Terminating the RF part of the quad circuit for back-compatibility

Selcuk Haciomeroglu

September 20, 2017

Figure 1: Circuit with the termination (when the RF is not connected).

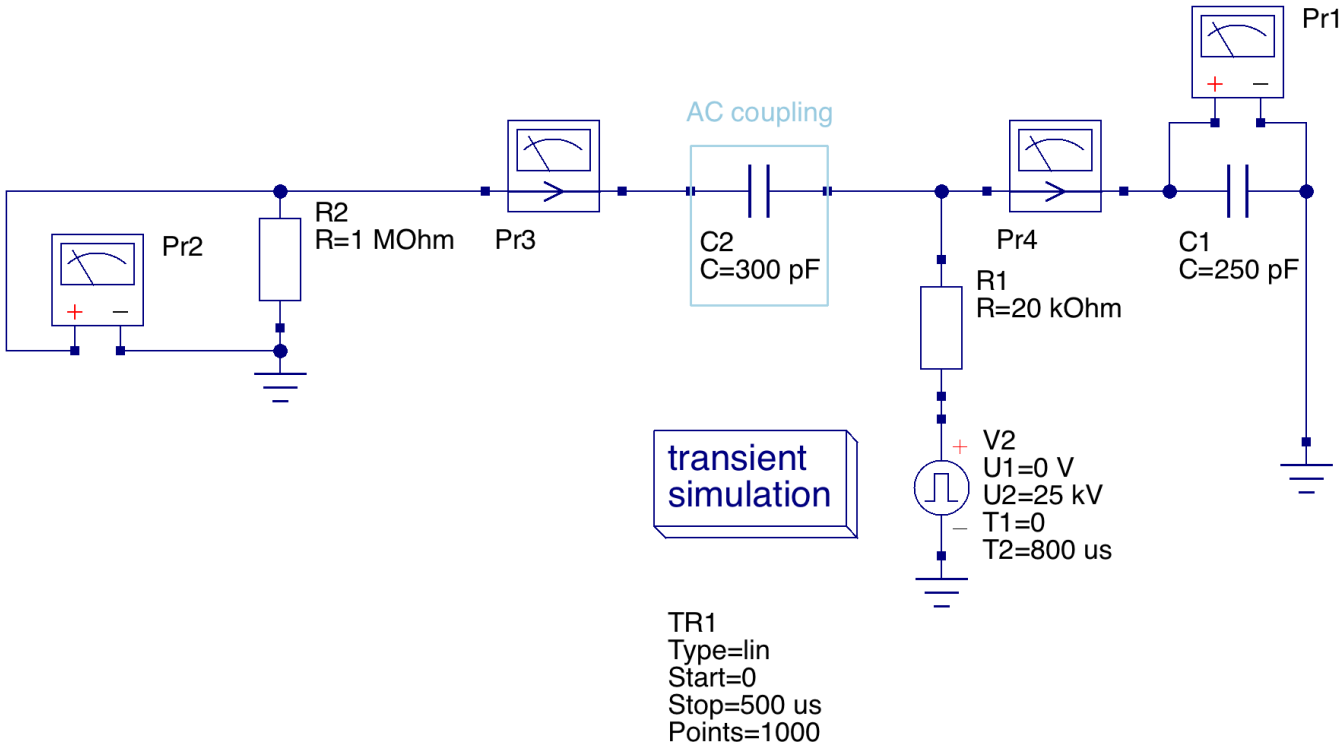
In his comment [1], Bill says that the current on the 1MΩ resistor is about 25 mA and may be problematic as an additional source of noise (See Figure 1 for the circuit). Indeed the current goes above 20 mA initially and then goes down (Figure 2).

Figure 5: Using a 1 pF capacitor in series decreases the time constant of the current across the 10 MΩ resistor.

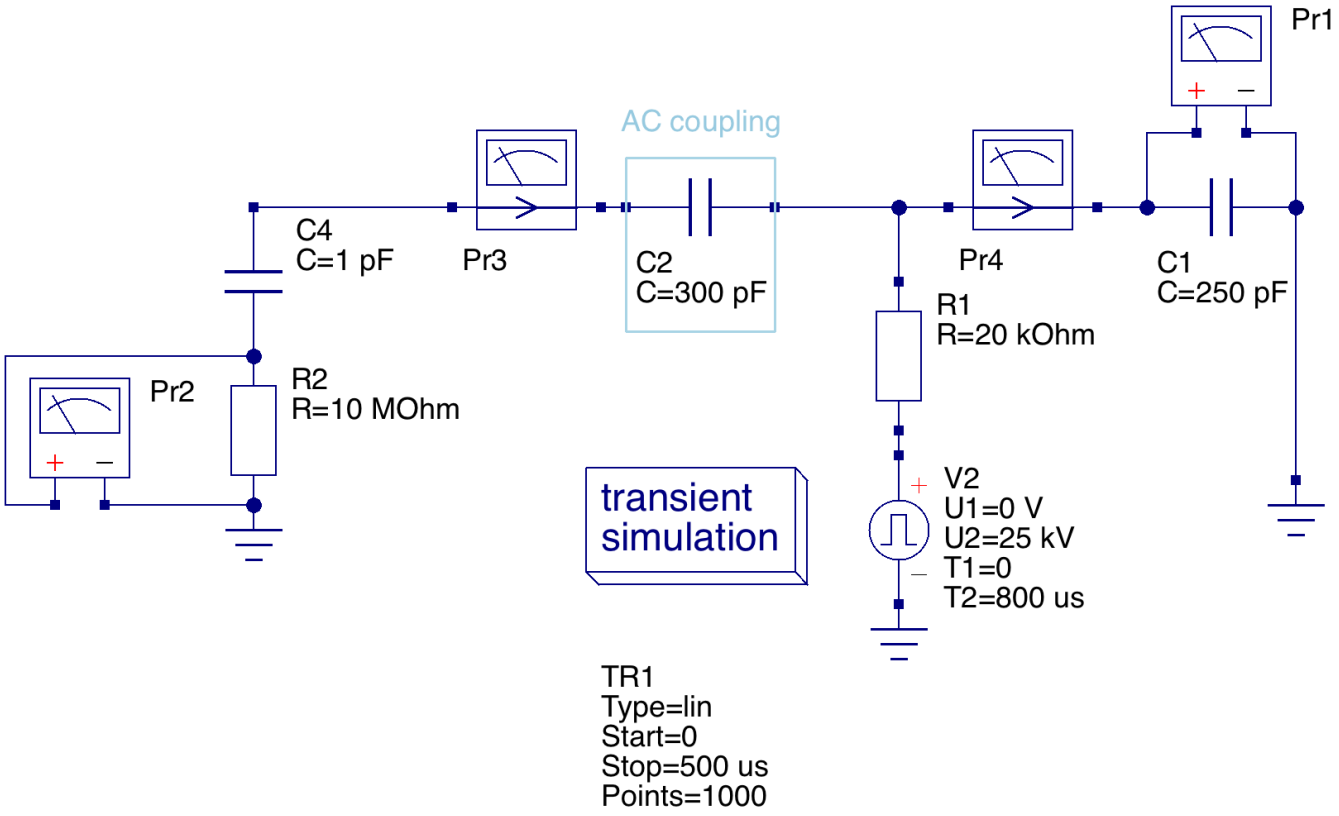
The major problem with the current on the 1 MΩ resistor is the long time constant. It can be shortened by using a small capacitor in series when the RF amplifier is not being used (Figure 5 shows the updated circuit with 10 MΩ resistor and a 1pF capacitor in series). As shown in Figure 6, the current on the termination becomes two orders of magnitude smaller than the current on the quad branch, with a similar width.

In several email exchanges, Bill and Hogan mentioned some concerns about terminating the RF part of the updated circuit with a 1 MΩ resistor. Indeed the current and voltage are not so small, although comparable to the original design. Still, we can make the effect of the termination much smaller by increasing the resistor from 1 MΩ to 10 MΩ and introducing a 1pF capacitor in series to that.

Figure 7: The rise time on the quad voltage is visually identical to that of the design with 10 MΩ, 1 pF termination.

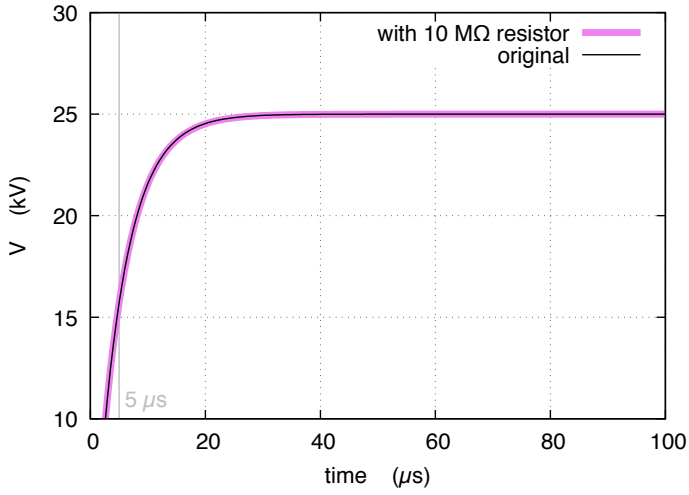
Another concern was about the rise time of the voltage on the quad. Figure 7 zooms in the rising time of the quad voltage of the original design and the design shown in Figure 5. They seem quite the same.
